# Improved Technical Specifications

## LaSalle County Station

Volume 5:  
Sections 3.4 and 3.5

Figure 3.4.1.5-1

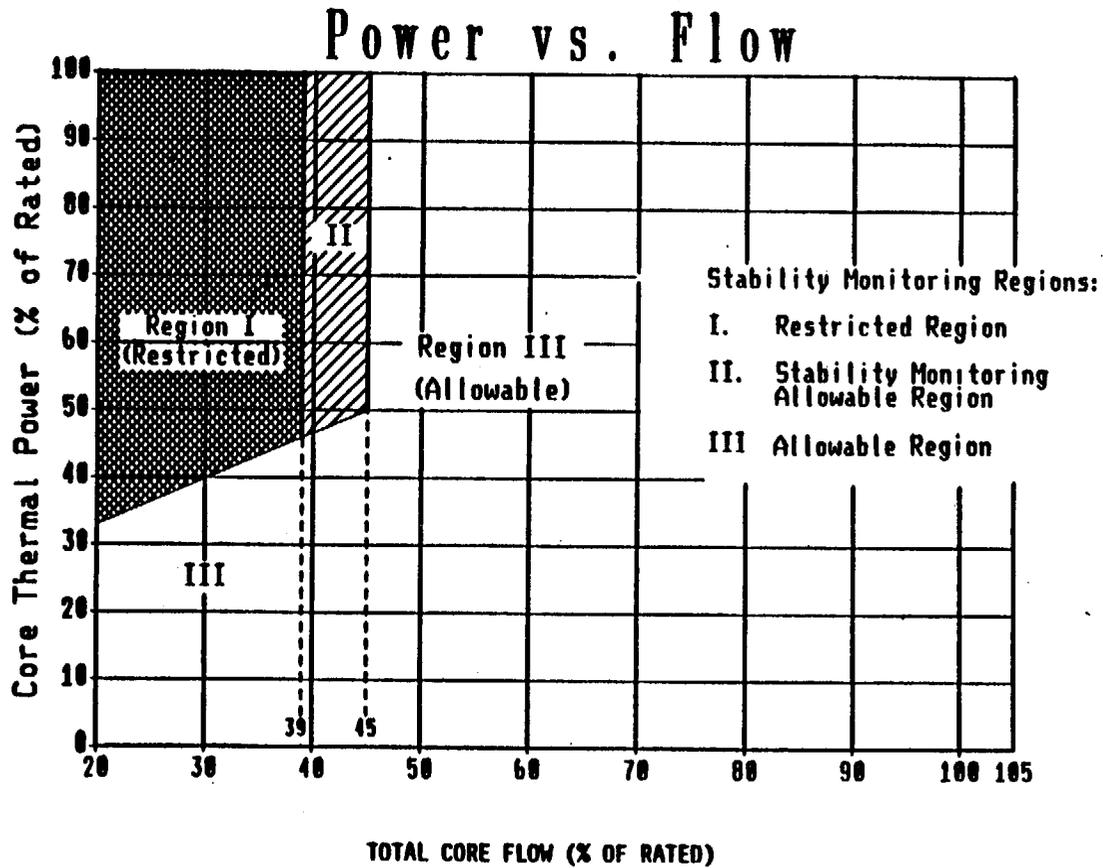
b. THERMAL POWER within Region III of Figure 3.4.1.5-1, or

ACTION A { c. THERMAL POWER within Region II of Figure 3.4.1.5-1 AND APRM and LPRM noise levels not exceeding the larger of: i) Three (3) times the established baseline noise levels or, ii) 10% peak-to-peak indicated noise level. [A.9]

ACTION C { a. In Region I of Figure 3.4.1.5-1:  
1. With at least 1 reactor coolant recirculation loop in operation ~~immediately initiate action to:~~  
a) ~~Decrease THERMAL POWER by control rod insertion, completing the power decrease within two (2) hours to exit Region I or,~~ [LA.2]  
b) ~~Increase core flow with the operating Recirculation loop(s), to exit Region I within two (2) hours.~~

2. Insert control rods to reduce THERMAL POWER and/or increase core flow to enter Region III of Figure 3.4.1.5-1 within the next 2 hours.

- A.8 CTS 3.4.1.5.a requires the total core flow to be  $\geq 45\%$  of rated core flow during forced core circulation operation and CTS 3.4.1.5.b requires THERMAL POWER to be within Region III of CTS Figure 3.4.1.5-1 (ITS Figure 3.4.1-1). Only one of these two requirements has to be met. The CTS 3.4.1.5.a restriction has been deleted since it is sufficient to make reference to be in Region III of ITS Figure 3.4.1-1. Since this change deletes a duplicate requirement, the change is administrative.

- A.9 CTS 3.4.1.5 requires APRM and LRPM noise levels to be within limits when in Region II of Figure 3.4.1.5-1 (ITS Figure 3.4.1-1). Proposed ITS LCO 3.4.1 requires recirculation loop operation within Region III of Figure 3.4.1-1. When recirculation loop operation is within Region II of Figure 3.4.1-1 (CTS Figure 3.4.1.5-1), ITS 3.4.1 ACTION A provides requirements to verify APRM and LRPM noise levels are within limits. Also, CTS 4.4.1.5.2 requires verification that core flow is greater than 39% rated core flow with recirculation loop operation is within Region II of Figure 3.4.1.5-1. 39% rated core flow is the lowest flow limit of Region II. Operation less than 39% rated core flow when in Region II results in entry into Region I of Figure 3.4.1.5-1. As such, ITS 3.4.1 Required Action A.3 requires verification that operation is not within Region I of Figure 3.4.1-1. The proposed changes are only changes in presentation preference and do not alter the intent of the existing requirements. Therefore, the changes are administrative.

Figure 3.4.1.5-1

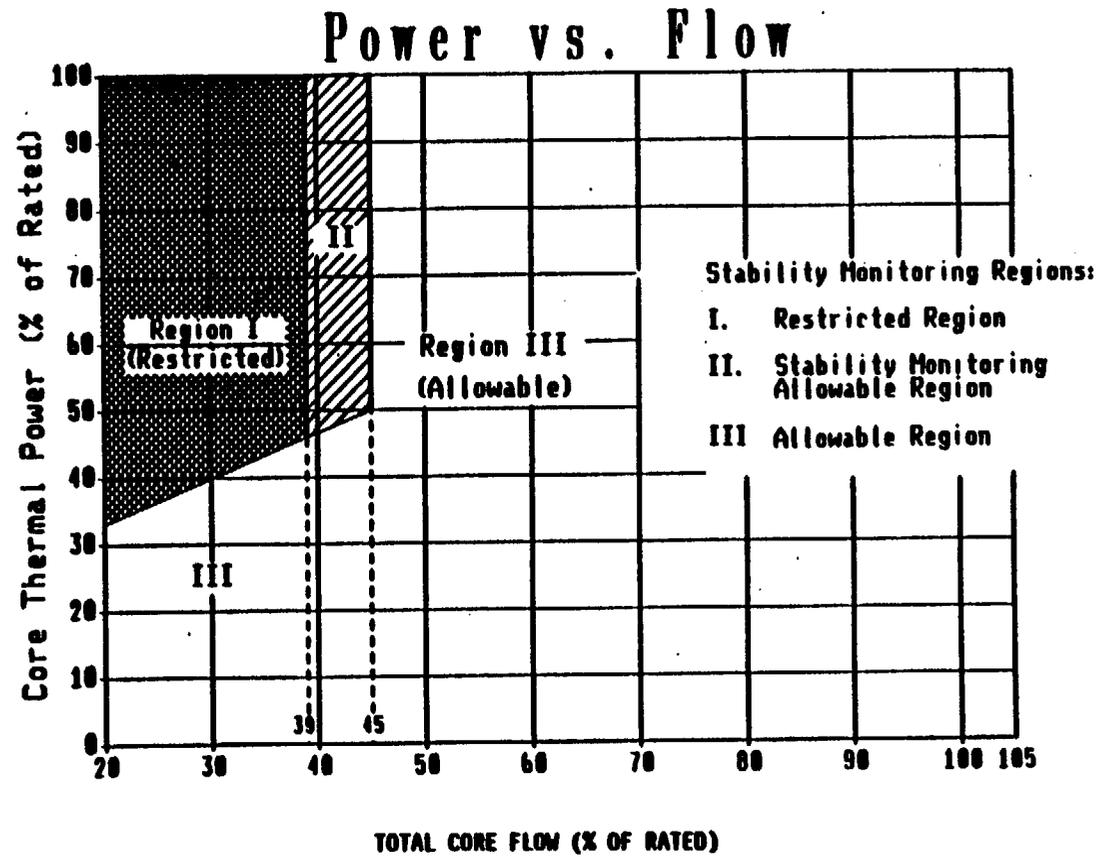
c. THERMAL POWER within Region II of Figure 3.4.1.5-1 AND APRM and LPRM noise levels not exceeding the larger of: 1) Three (3) times the established baseline noise levels or, 2) 10% peak-to-peak indicated noise level. A.9

a. In Region I of Figure 3.4.1.5-1:

b. In Region II of Figure 3.4.1.5-1, with APRM or LPRM neutron flux noise levels exceeding the larger of: i) Three (3) times the established baseline noise levels, or ii) 10% peak-to-peak noise indication.

2. ~~Insert control rods to reduce THERMAL POWER and/or increase core flow to enter Region III of Figure 3.4.1.5-1 within the next 2 hours.~~

- M.1 Not used.
- M.2 CTS 3.4.1.5 Action b.2 requires entry into Region III of Figure 3.4.1.5-1 within 2 hours following attempts to restore APRM and LPRM flux noise levels to within limits in 2 hours. This allows a total of 4 hours (2 hours to restore APRM and LPRM noise levels and 2 hours to enter Region III of Figure 3.4.1.5-1) to operate in Region II with APRM and LPRM flux noise levels outside established limits. ITS 3.4.1 Required Action B.1 allows only 2 hours to satisfy the requirements of the LCO (i.e., enter Region III of ITS Figure 3.4.1-1). The Completion Time of 2 hours is reasonable, based on operating experience, to restore plant parameters in an orderly manner without challenging plant systems. Since this change reduces the time to enter Region III of CTS Figure 3.4.1.5-1 (ITS Figure 3.4.1-1) from 4 to 2 hours, the proposed change is considered to be more restrictive.

Figure 3.4.6.1-1

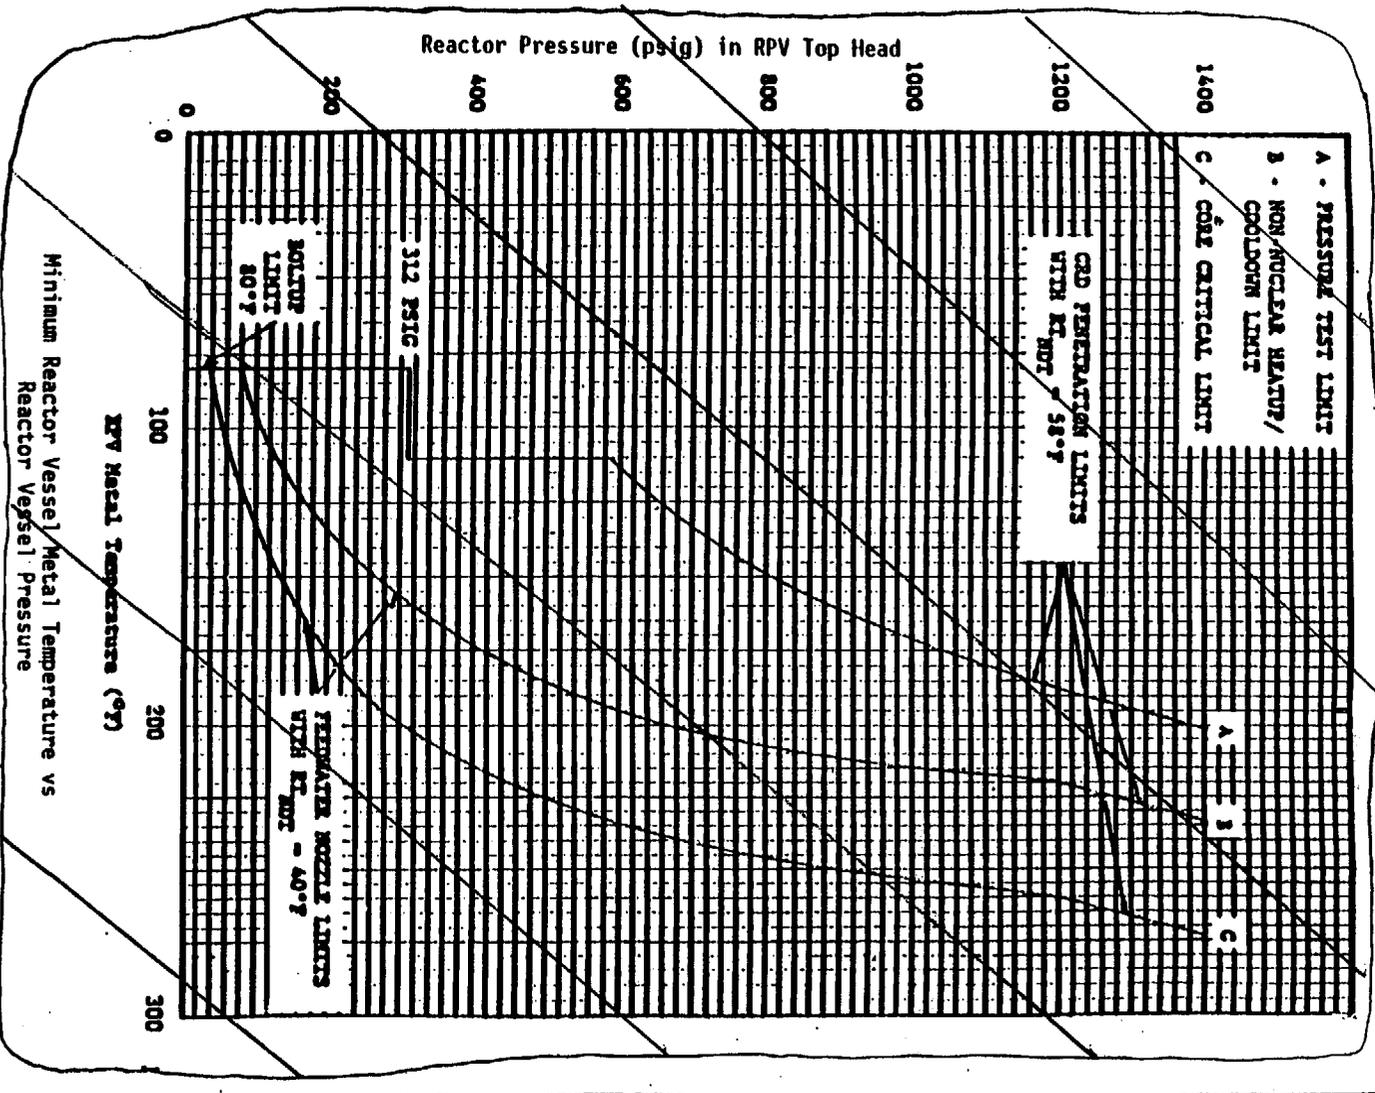
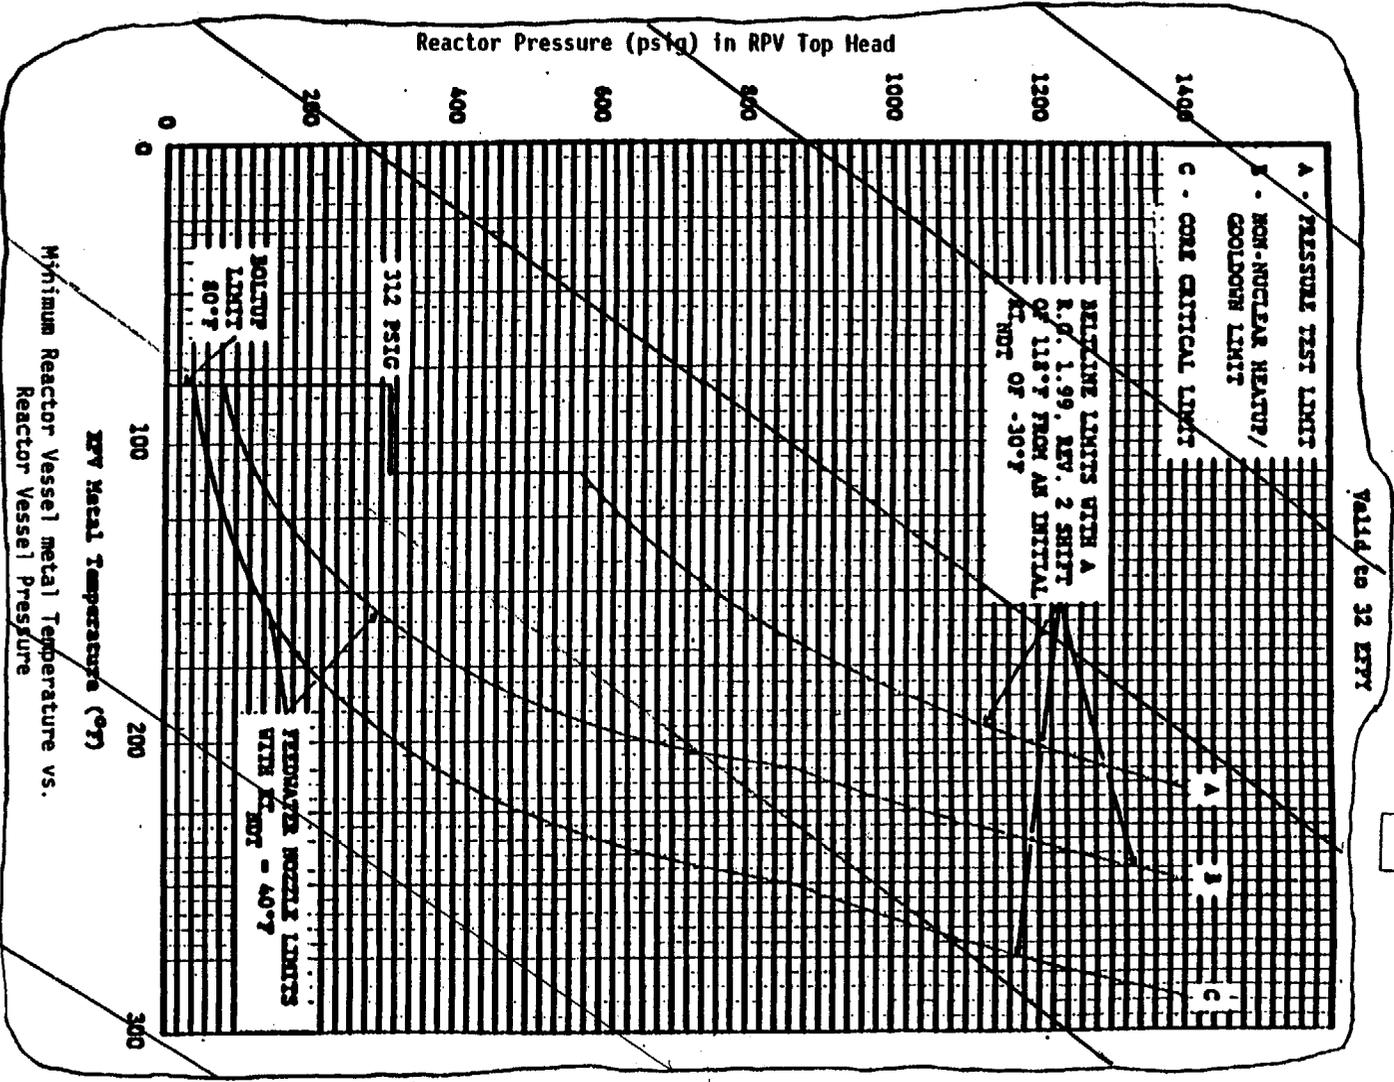
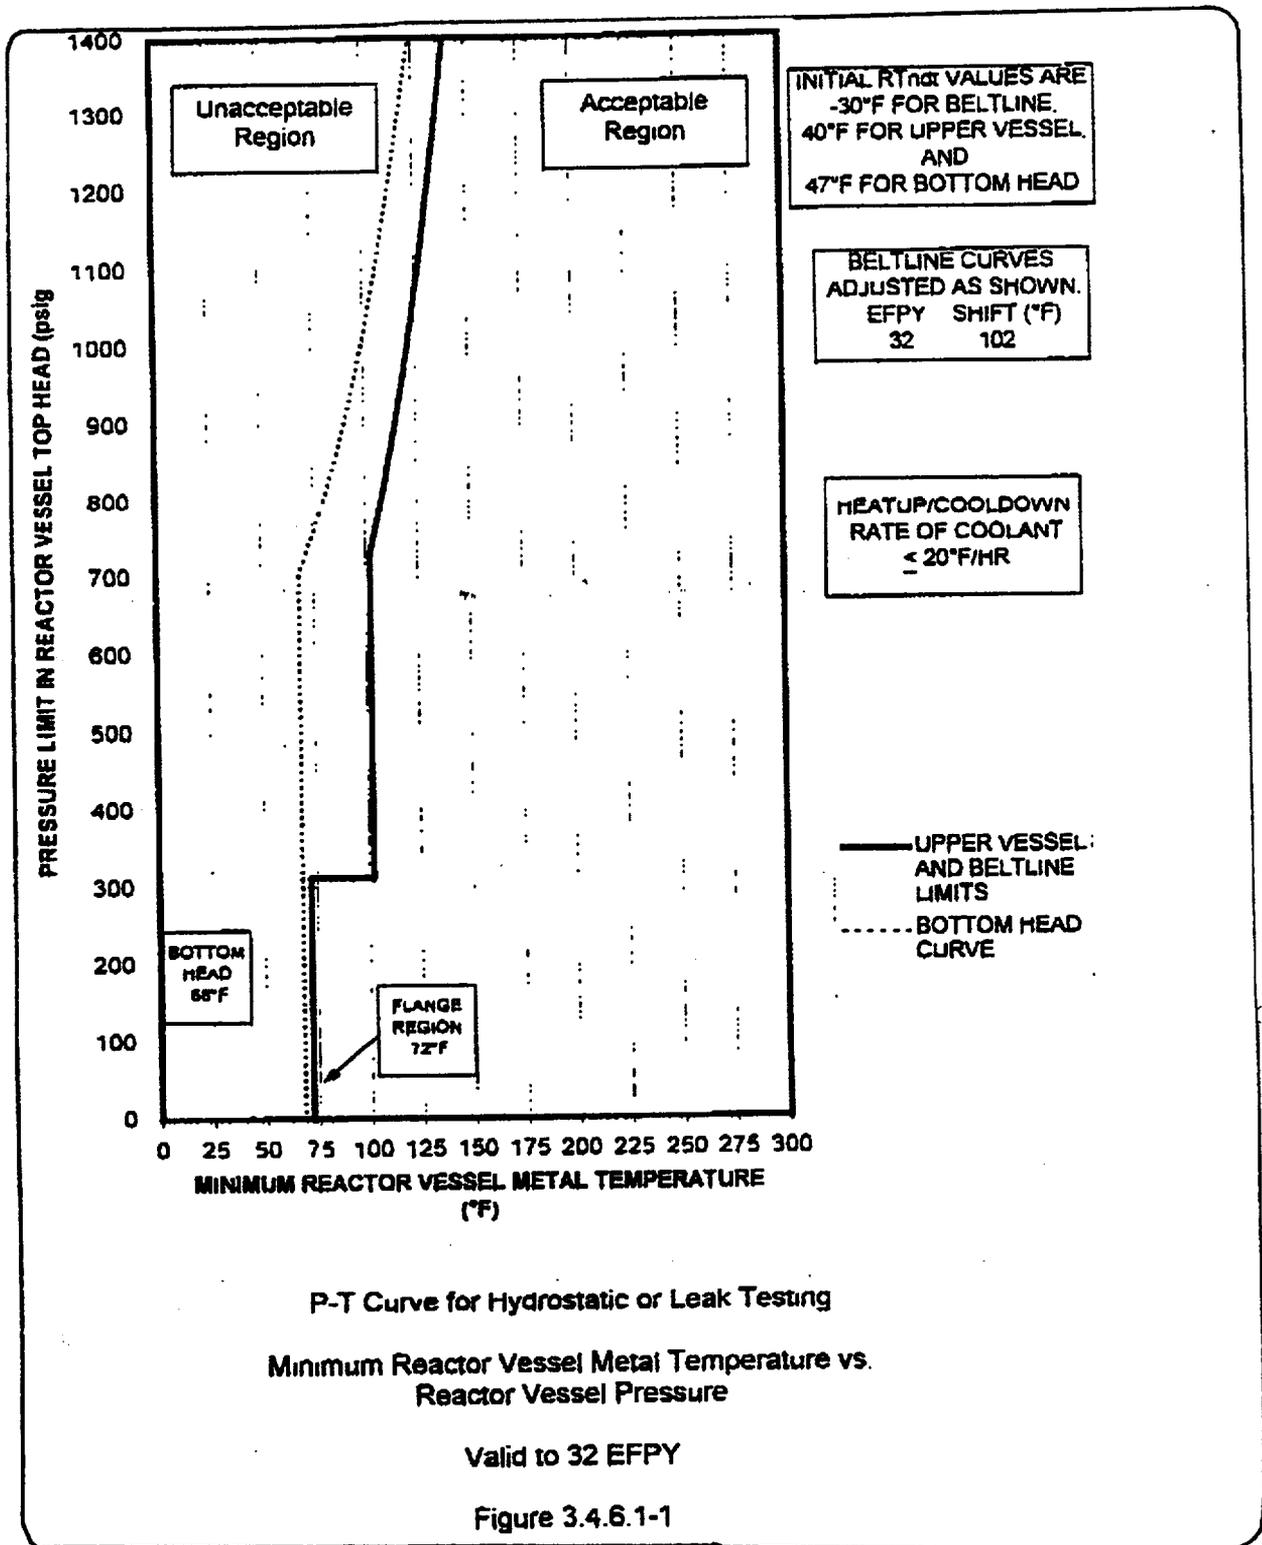
Replace with Figures 3.4.6.1-1,  
3.4.6.1-1a and 3.4.6.1-1b

- LA.1      The specific requirements in CTS 4.4.6.1.1 and CTS 4.4.6.1.2 that operation be to the right of the limits lines of Figures 3.4.6.1-1 and 3.4.6.1-1a are proposed to be relocated to the Bases. These details are not necessary to ensure the P/T limits are met. The requirements to maintain the P/T limits in accordance with the Figures are still maintained in ITS 3.4.11, SR 3.4.11.1, and SR 3.4.11.2. Therefore, the relocated requirements are not required to be in the ITS to provide adequate protection of the public health and safety. Changes to the Bases will be controlled by the provisions of the proposed Bases Control Program described in Chapter 5 of the ITS.
